Great Planes Ultra Sport + Product Improvement Sheet

Introduction

Fix for the Main Landing Gear Wire (WBNT315)

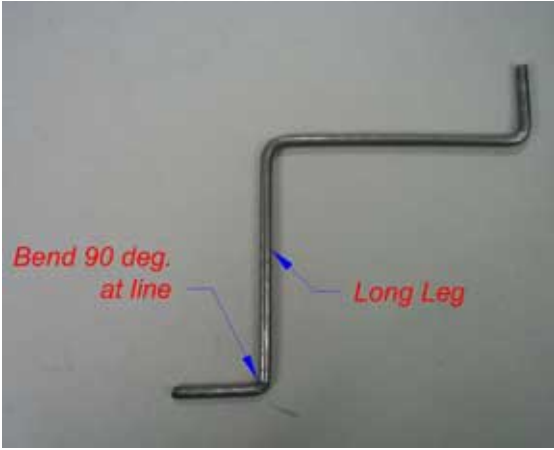
The first run of Ultra Sport Plus kits inadvertently was shipped with the wrong main landing gear wire. The 5/32" steel wire labeled as WBNT315 (main gear wire) has one leg that is longer than it should be. The length of the legs should be: 3-1/3" (85mm) for the short leg and 3-15/16" (100mm) for the long leg. Please check if your main landing gear wire is of the correct dimensions. If it is not, you will need to following in order to be able to use this landing gear wire in your kit.

- ❑ 1. Cut the long leg of the wire at the bend as indicated above on both landing gear wires.

- ❑ 2. Draw a line 1-1/4" [32mm] away from the end of the long leg as indicated above on both main landing gear wires.

□ 3. Bend each wire 90 degrees at the line as shown above. Install the wire as per instructions. The bend just made goes into the wing mounting blocks.
